## Landscape Referral Response

<b>Application Number:</b>	DA2025/0539
<b>Date:</b>	26/06/2025
<b>Proposed Development:</b>	Alterations and additions to a dwelling house including a swimming pool
<b>Responsible Officer:</b>	Olivia Ramage
<b>Land to be developed (Address):</b>	Lot 52 DP 12838 , 154 Plateau Road BILGOLA PLATEAU NSW 2107

Amend retaining and stairs to maintain existing levels around Tree 9

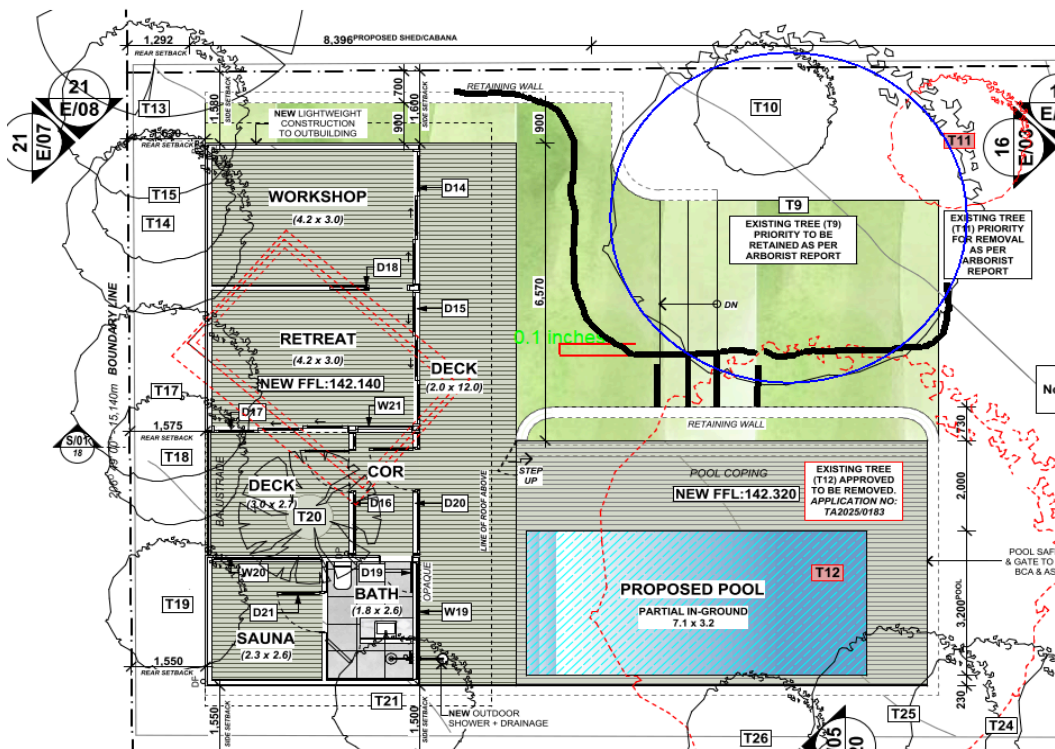
There is some inconsistency between the trees indicated for removal in the Report and trees indicated on the plans. It is evident that not all the trees indicated in the Arborist's report to be removed need to be removed.

- Tree 12 (located in the position of the new pool) is noted to have been approved for removal under a separate application. No objections are raised to removal of the tree and subsequent pool location.
- Trees 9 and 10 are indicated for retention on the plans, but are not able to be retained as indicated in the Arborist's Report due to excavation and construction of retaining walls and terrace to the Cabana building. Reduction of the extent of excavation, retaining walls and terrace would enable retention of the trees, ide as indicated in the sketch below.
